File AC – Response to both Referees' RC1 & RC2 on Esurf-2021-71

to
  Revised MS:
  Title: "Analytical approach for beach flanking downdrift of natural groin induced by winter high waves: Case study of Jeongdongj in Korea"
      1. Introduction

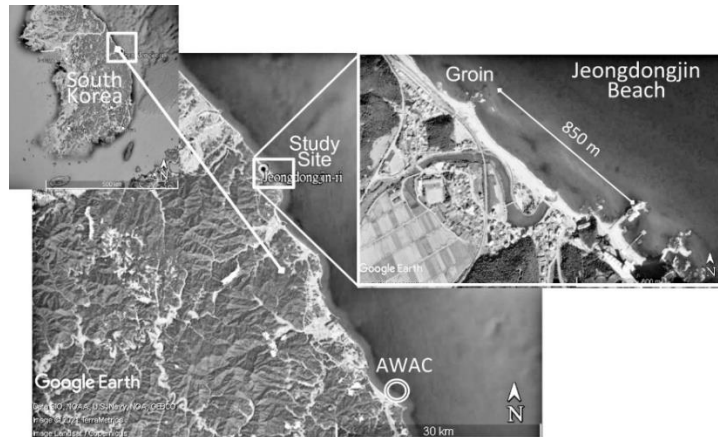
R1 [S10-2] [OL 274–276] "As shown in Fig. 17, where … to September 27th, 2013 to November 21st, 2016." >>> to be relocated after the new Fig. 10 at the end of new Sect. 3.1, and the two original sentences are revised as "Nearshore wave data were collected by an AWAC wave meter at a depth of 32.4 m to the south of Jeongdongjin Beach. From the data recorded over three years (27 September 2013 to 21 November 2016), the distribution of the annual mean wave direction is plotted (Fig. 11). As shown in Fig. 11, the prevailing wave direction was within -15° and +10° from the normal to the shoreline."

[OL 282–283] Original Fig. 17 to be re-numbered as new Fig. 9 and relocated under new Sect. 3.1.

A1 [S10-2] We renumber the original Fig. 17 to Sect. 3 and Fig. 18 to Sect 3.1, as well as revise the sentences .

[L 223-227] Nearshore wave data were also collected by an AWAC wave meter (Fig. 10) at a depth of 32.4 m to the south of Jeongdongjin Beach. From the data recorded over three years (27 September 2013 to 21 November 2016), distribution of the annual mean wave direction is plotted (Fig. 12). The results reveal the

In addition, the renumbered figure is attached below.
